UNITED STATES PATENT AND TRADEMARK OFFICE

APPLICATION NO.	FILING DATE	FIRST NAMED INVENTOR	ATTORNEY DOCKET NO.	CONFIRMATION NO.
10/815,993	04/02/2004	Gary W. Brondt	44948	7270

Office Action Summary

DETAILED ACTION

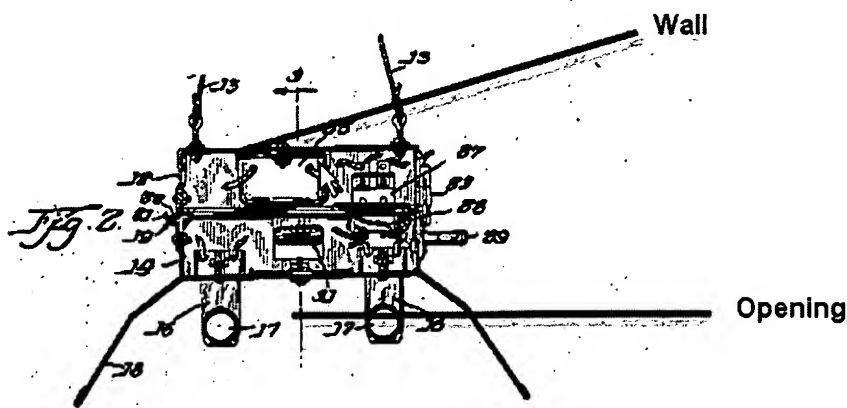
With respect to claims 1 and 2, Westby teaches a lighting fixture (fig 1), comprising a housing 12 supporting a first lamp 17 including a wall and an opening opposite the wall (drawn in below). Westby also teaches a first suspension cable 13 coupled with a housing. The cable includes opposite first and second ends (shown in Fig 1, not numbered) the first end of the suspension cable having a first loop. Westby fails to teach a tongue which engages the loop of a cable. Ambasz teaches a tongue 46, integrally formed with the wall of the housing, which engages a suspension cable. It would have been obvious for one of ordinary skill in the art to combine the tongue of Ambasz with the lighting fixture of Westby in order to provide a simpler device with fewer parts to suspend the lighting fixture from a support.

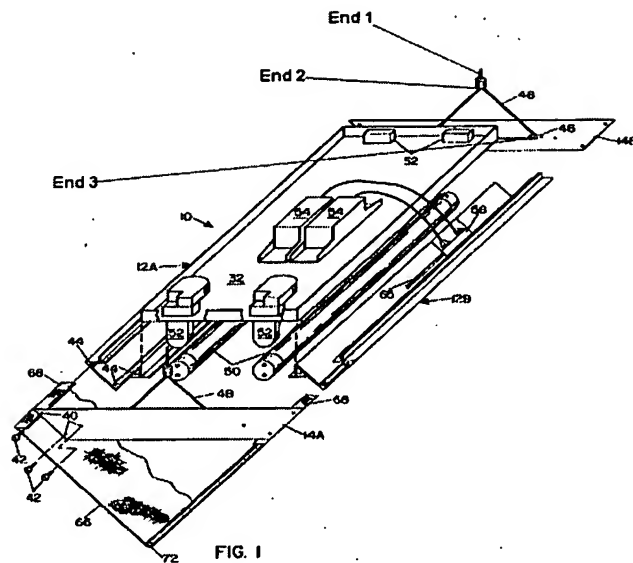
As for claim 3, Westby and Ambasz teach the lighting fixture of claim 1, Ambasz teaches a second tongue 46 (not visible in the device because of the angle of the drawing), and a second suspension cable 48 includes a third end (drawn in below) with a second loop (end 3 makes up the second loop) engaging the tongue. It would have been obvious for one of ordinary skill in the art to combine the tongues and suspension cable arrangement of Ambasz with the lighting fixture of Westby in order to be able to hang the device from a support using less cables than Westby's support structure, which requires less materials and makes it less expensive.

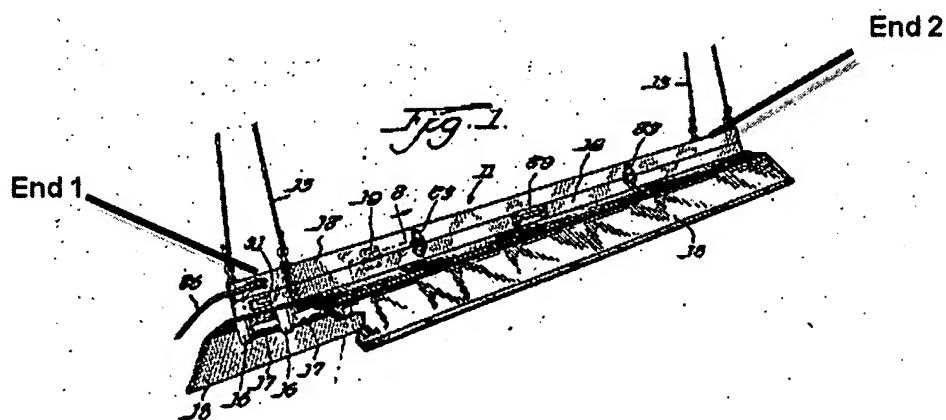
As for claim 4, Westby and Ambasz teach the lighting fixture as discussed above, wherein the wall of the housing includes opposing ends (drawn below) and the first tongue 46 is disposed adjacent to one of the ends. Westby discloses attachment devices for the cables, at each end, but does not teach tongues. See the discussion in regard to claim 1 for the tongues.
